Customer Notification

V850E/Dx3

32-Bit Single-Chip Microcontrollers

Operating Precautions

Figure: Additional Measures in case AFCAN clock is active when waking up

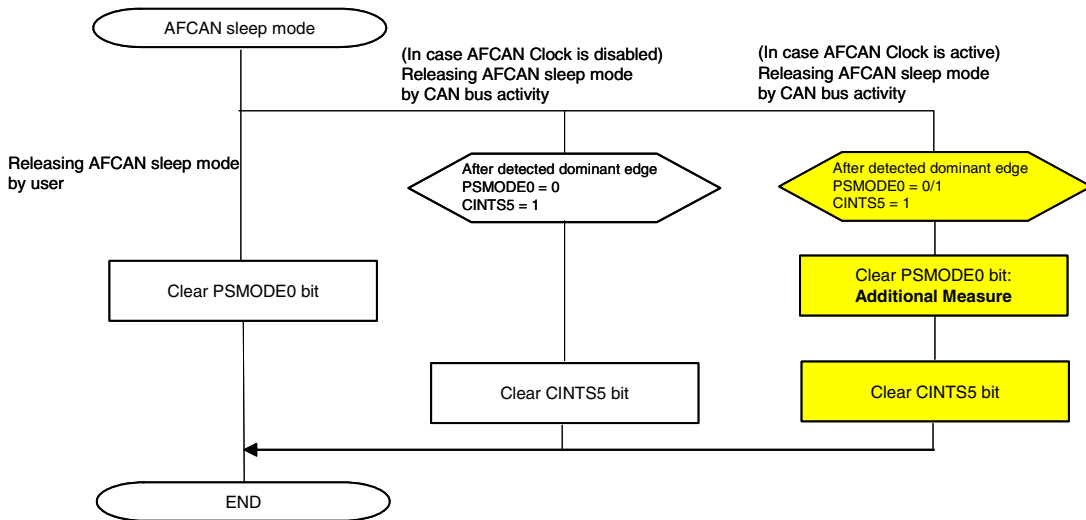
The following flowchart illustrates, how and whether additional measures have to be taken in software, to avoid the *wakeup dead time*.
